SB-GA8-2013-99

Service Bulletin

Inspection and modification of Strut Pick-up ribs – Rib no. 5 and Rib no. 6

Figure 1: Inspection Region on Strut Pickup Ribs

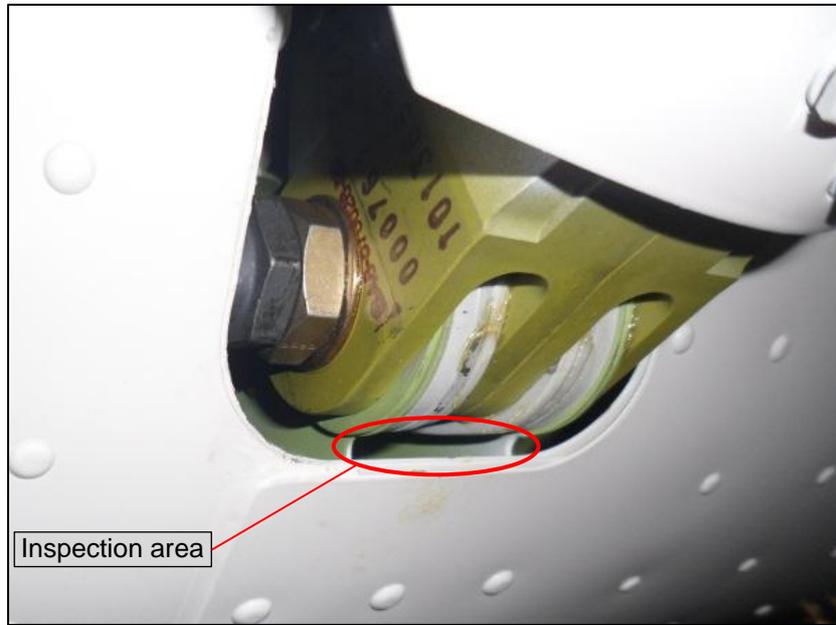
1. Before any of the procedures prescribed in this service bulletin are carried out, ensure that the aircraft is secured on stable ground, preferably a hanger.
2. Unscrew and remove the strut/fuselage fairings (GA8-570017-013 and GA8-570017-015).
3. Inspect the strut pick-up ribs at the point just below the connection between the wing strut and the fuselage. Refer to Figure 1 below

Figure 2: Region of potential crack development

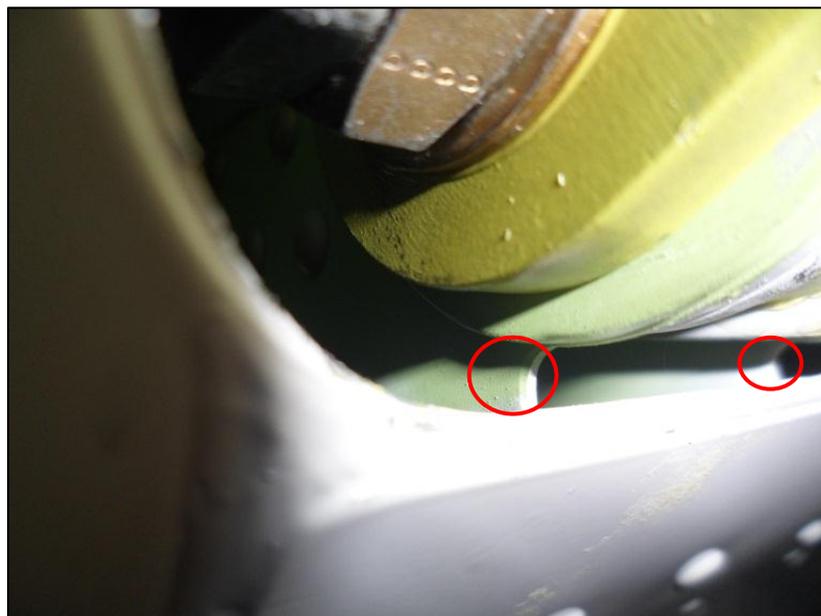
4. If a crack is found on any of the ribs within the region shown by red circles in Figure 2, proceed to step 5, otherwise skip to step 12.

Figure 3: Belly Skin Cut-Out

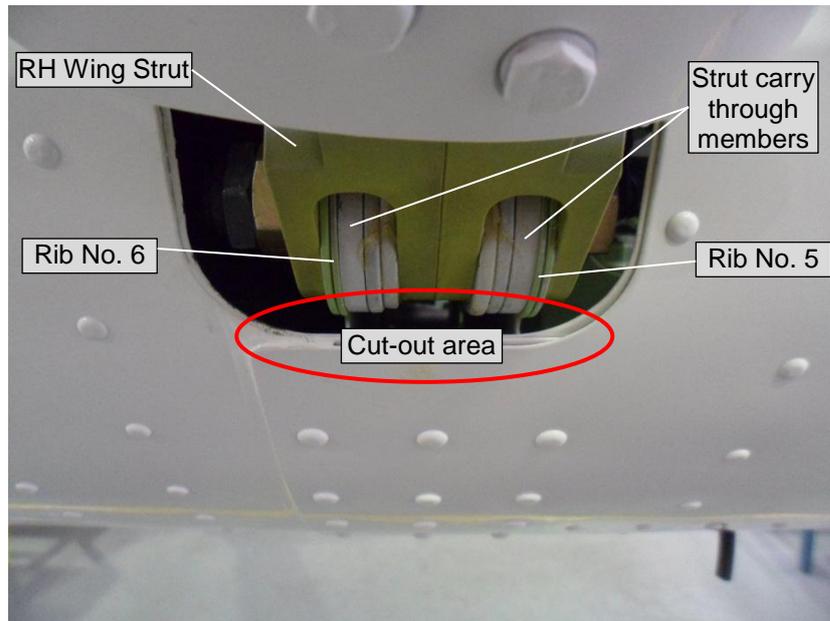
5. Open up the lower part of the cut out (Figure 3) within the fuselage belly skin to match rib modification prescribed in step 6. Maintain radius of 1.0 in (25.4 mm) around the corners of belly skin.

Figure 4: Rib modification

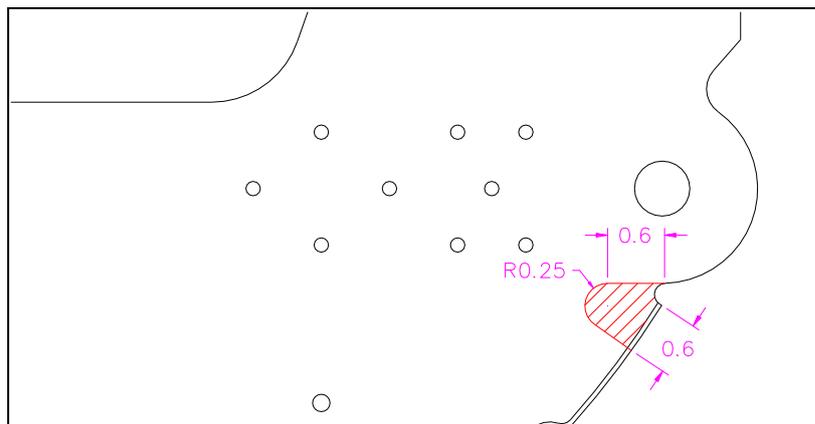
6. Remove minimum material within the shaded area in Figure 4, sufficient to remove the crack and achieve maximum radius.

MODIFICATION OF THE RIB SHOULD BE DONE WITH EXTREME CAUTION TO AVOID DAMAGE TO SURROUNDING STRUCTURE ESPECIALLY TO THE STRUT CARRY THROUGH LAMINATES.

7. After the rib modification, inspect the area again using a suitable NDT method to ensure that the crack has not propagated any further into the rib.
8. If the crack has propagated beyond the shaded area, contact GippsAero immediately for an appropriate repair procedure. Otherwise proceed to step 9
9. Deburr all edges making sure that no sharp edges remain.
